EASTERN CORRIDOR SEGMENTS II AND III (PID 86462)
**US 50 CORRIDOR FOCUS AREA
ADVISORY COMMITTEE MEETING NOTES**

MEETING #3 NOTES

Sept. 7, 2018

Figure BIKE-5

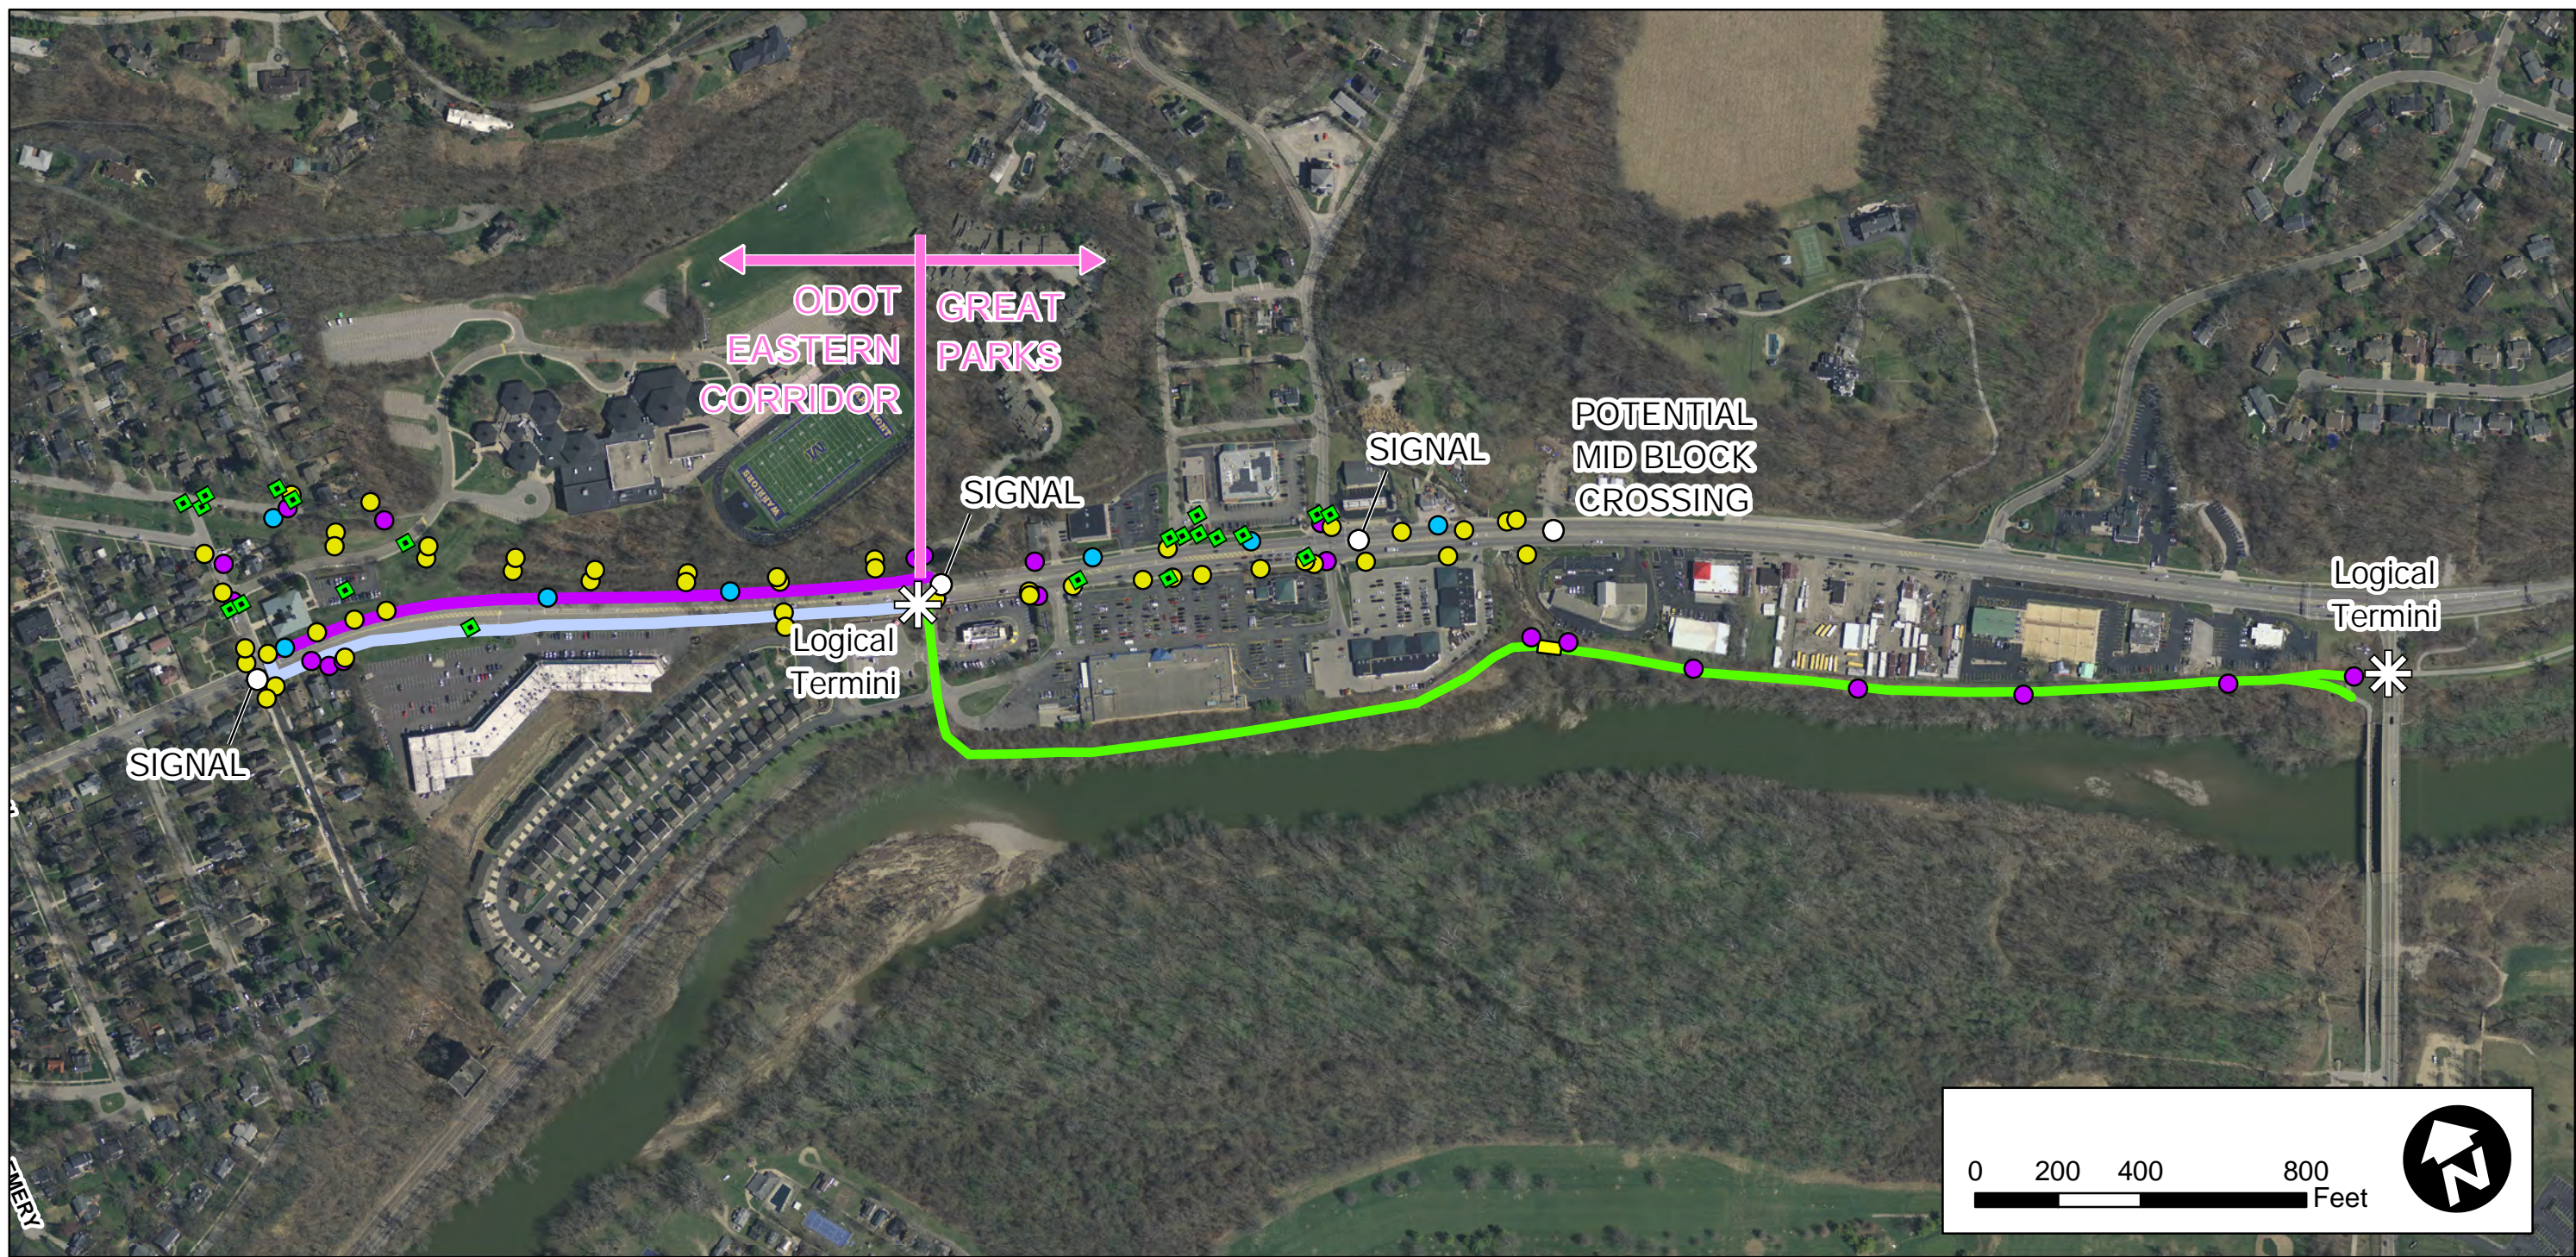
Great Parks of Hamilton County, Columbia Township and their consultant, IBI, are currently studying options to connect bicyclists and pedestrians with the Little Miami Trail. ODOT will wait until their study is completed to further develop concepts for bike/pedestrian connections within this portion of the US 50 Corridor. However, bike/pedestrian concepts suggested at the first Advisory Committee meeting were briefly reviewed in more detail with Great Parks and Columbia Township representatives and other Advisory Committee members during the May 18 meeting.

- ODOT has not provided information to Mariemont regarding proposed bike paths. US 50 focus area was only area where no bike plans were provided to date. Any proposed bike path(s) through Mariemont requires Mariemont approval.

- This alternative is being advanced by Great Parks/Columbia Township.
